SUBJECT: Dairyland Power Cooperative
La Crosse Boiling Water Reactor (LACBWR)
Possession-Only License DPR-45
Annual Decommissioning Plan: Revised December 2008

DECOMMISSIONING PLAN, revised December 2008

2008 LACBWR Decommissioning Plan Review

FIGURE 6.1

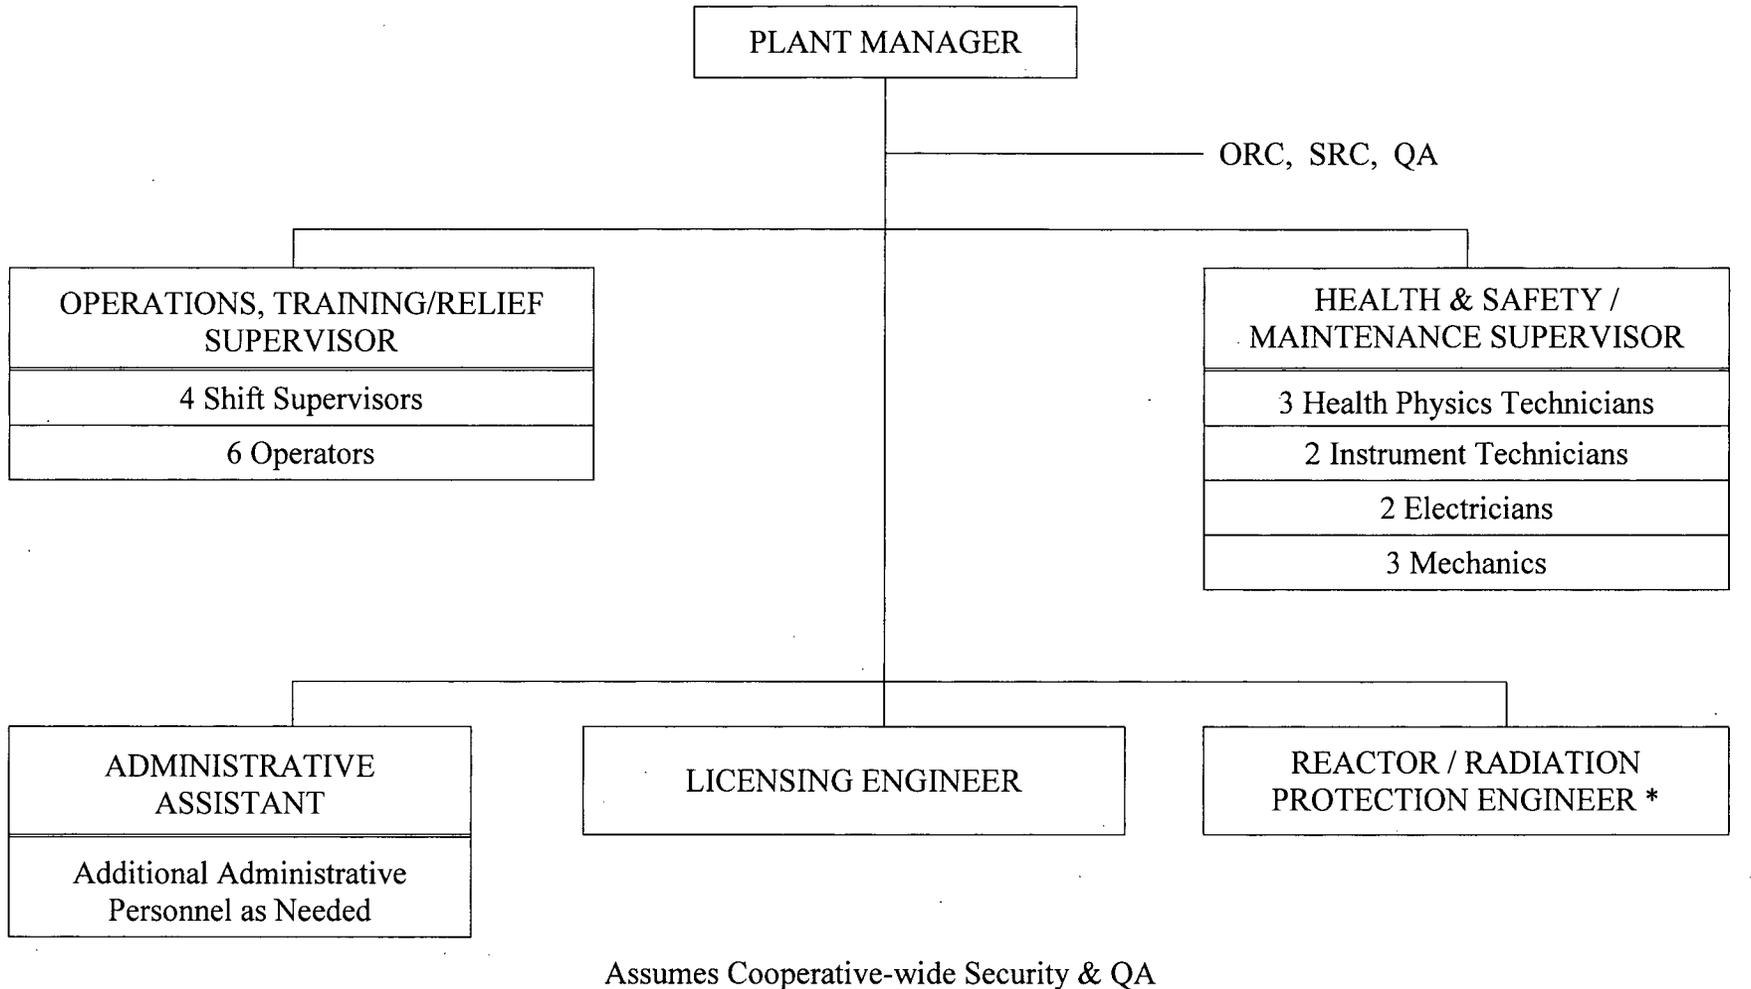
- Figure 6.1 Figure depicting minimum required staffing is revised to depict LACBWR organizational reporting adjustments associated with *Operations, Training/Relief Supervisor* and *Health and Safety/Maintenance Supervisor*.
